**25 Old Gloucester Street,
London WC1N 3AF**

**Basement Impact Assessment
Audit**

For
London Borough of Camden

Project No.
14006-51

DRAWING TITLE
Drawing Demonstrating Relative levels between 25 Old Gloucester Street and surrounding properties..

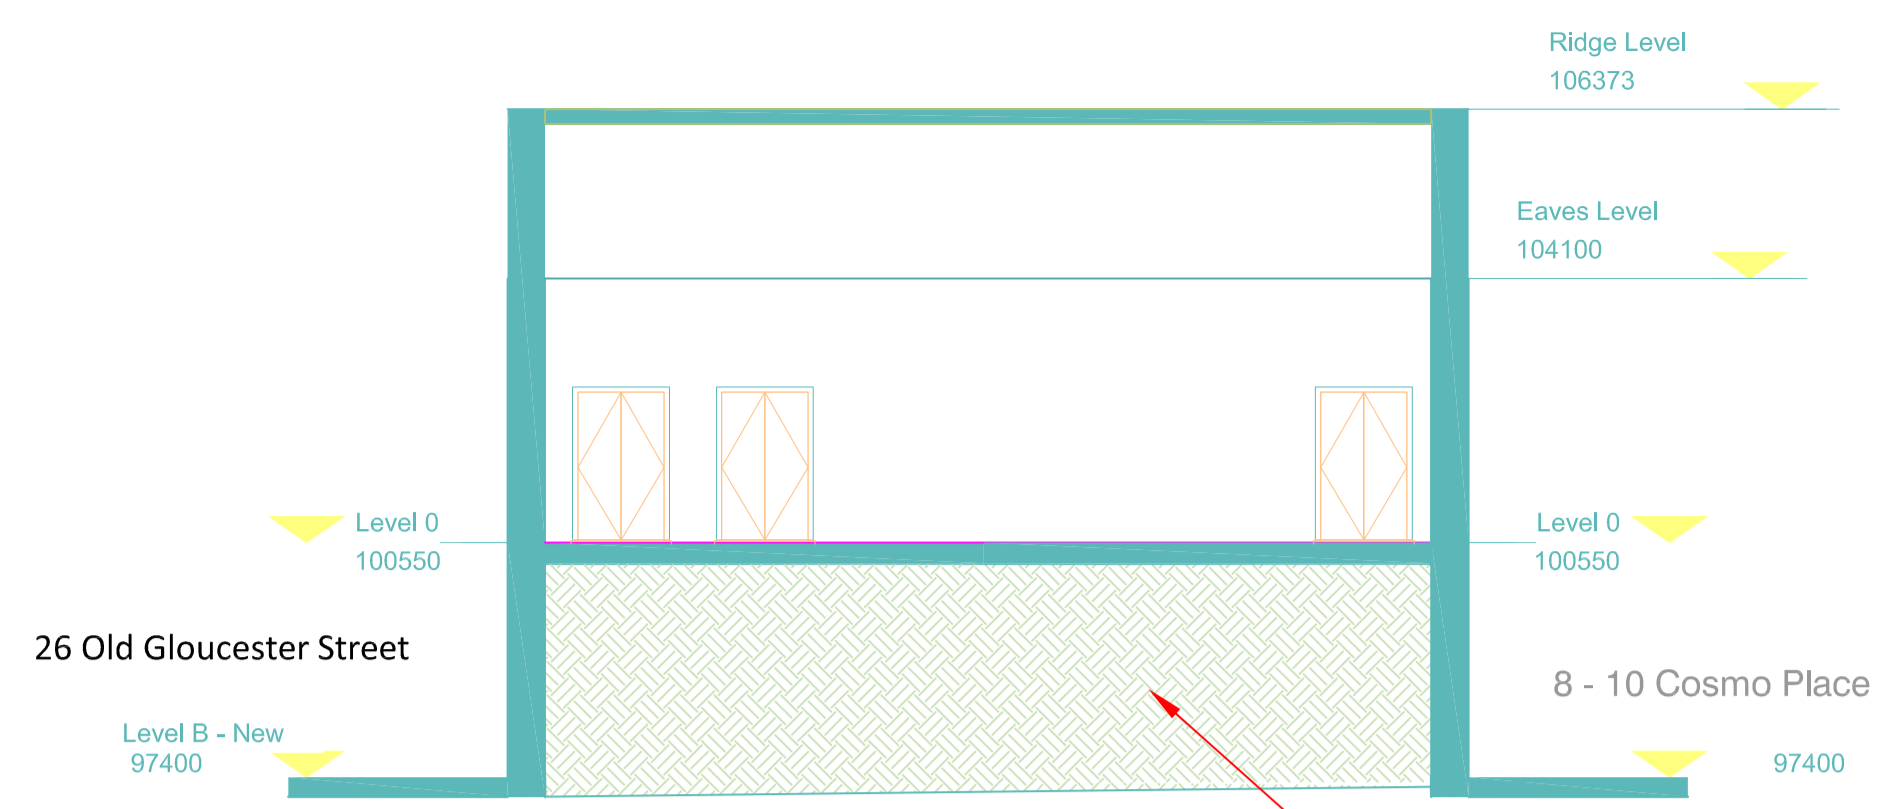
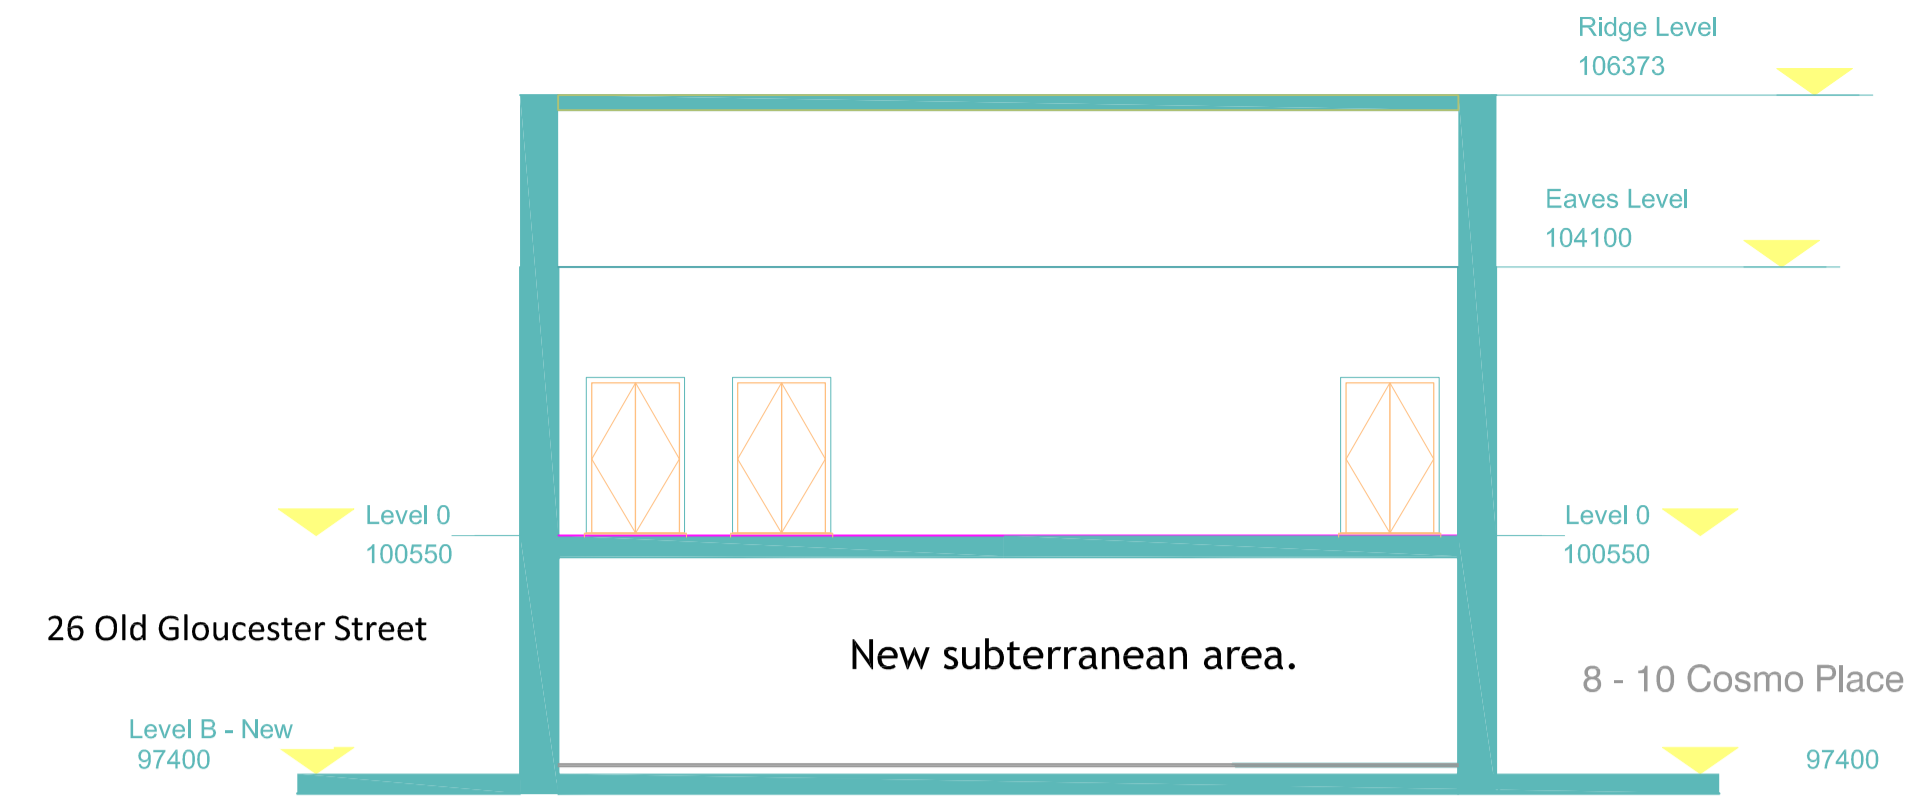
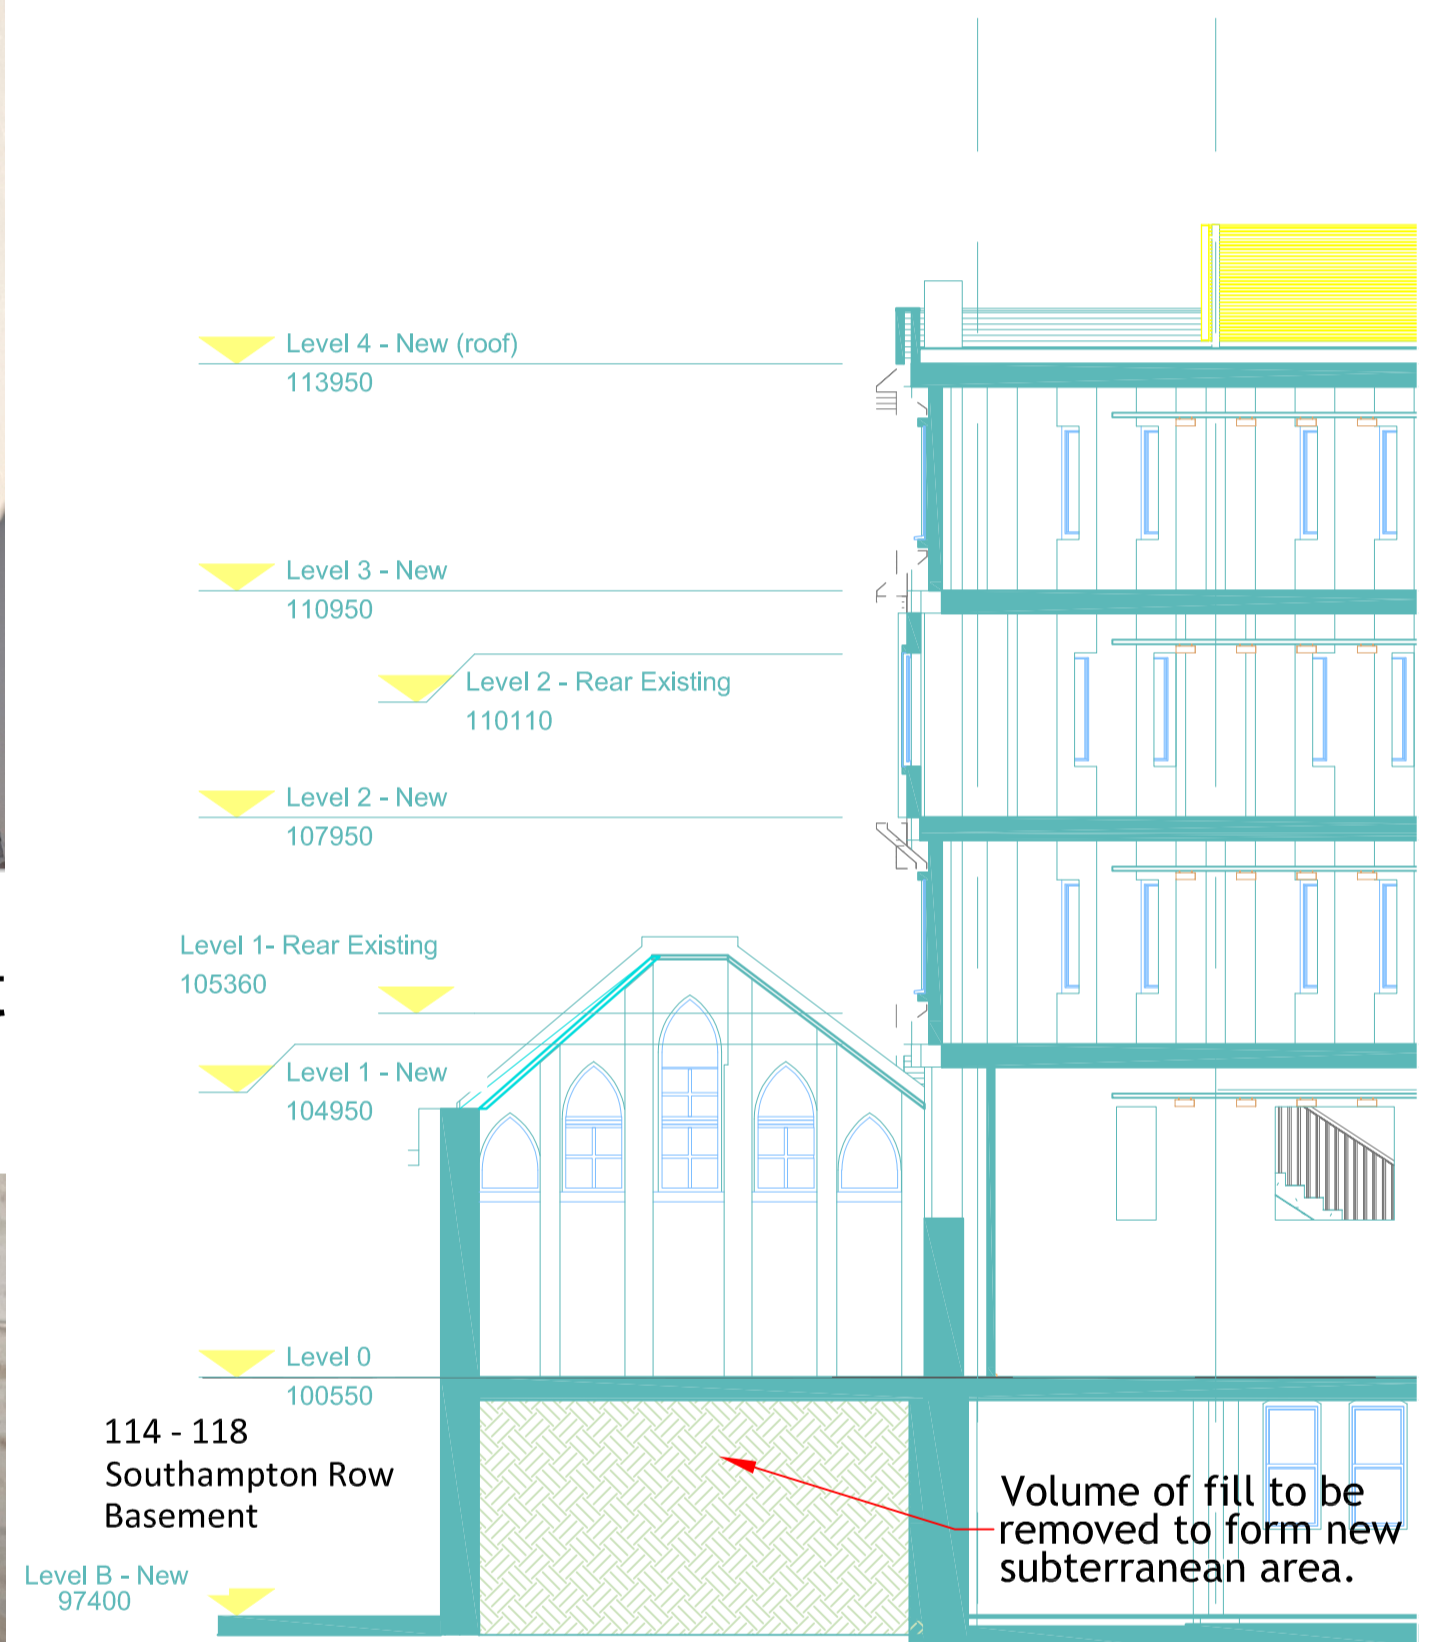
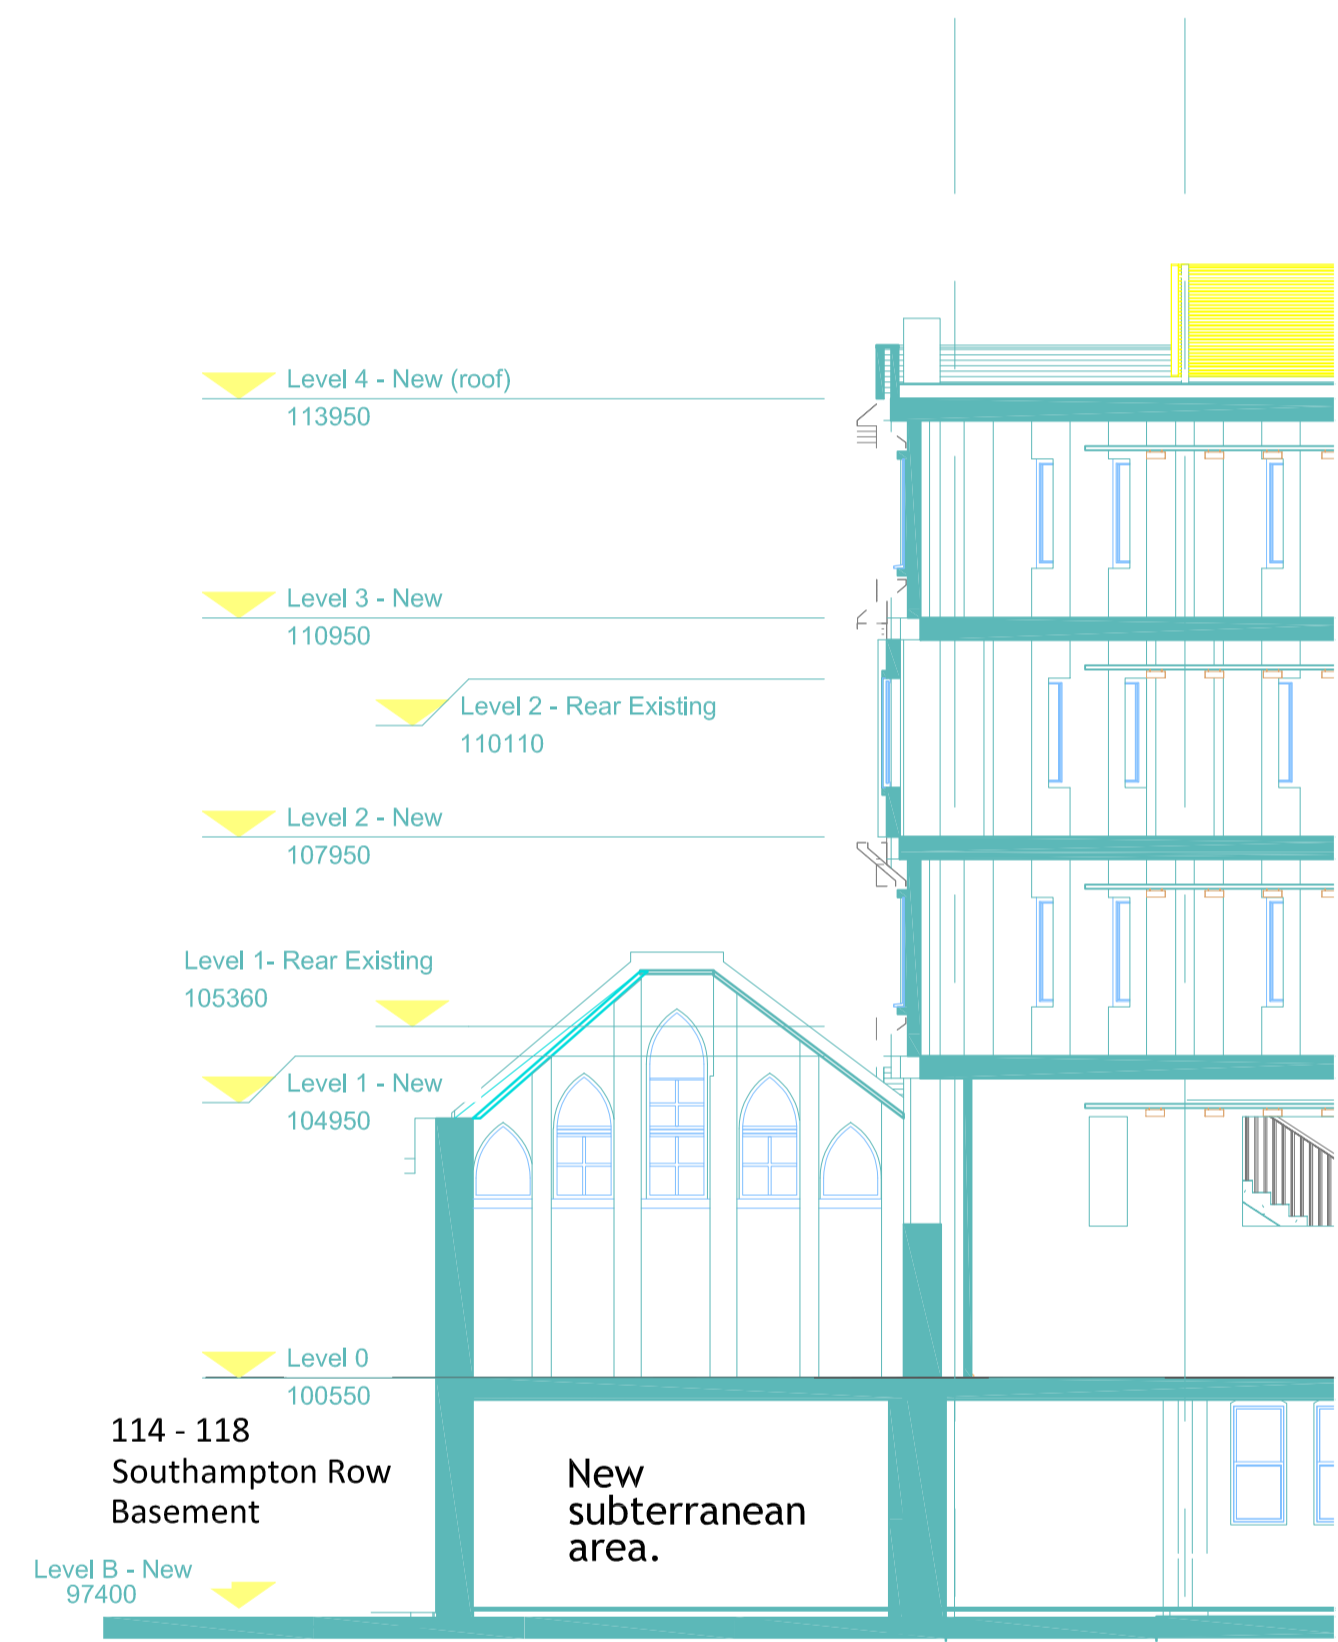
Following an inspection on the 25th January 2024 we can confirm all the properties around the proposed excavation have basements to a similar depth as the proposal. To this extent the proposal put forward for planning consent will only see the ground between the other basements being removed. To this extent I do not consider this action as the formation of a basement in the true sense of the word but more a unifying of all the subterranean areas within the locality of the proposal.

To demonstrate the above, we have prepared the attached drawing 23056-014 which includes photographs from within the adjoining basements and sections showing no temporary works will be necessary nor the formation of any retaining structures will be necessary. I would therefore propose that a Basement Impact assessment is no longer required for the scheme.

- 4.5 Following the D1 issue of the BIA Audit report, additional documents comprising a letter and drawing were provided to confirm that all the properties neighbouring the proposed development have existing basements that extend to a depth comparable to the proposed extension. As such, it has been confirmed that no underpinning will be required. The additional documents submitted are included in Appendix 3 of this report.

The basement will not significantly increase the depth relative to the neighbouring properties and as we see the situation now there will be no requirement for underpinning.
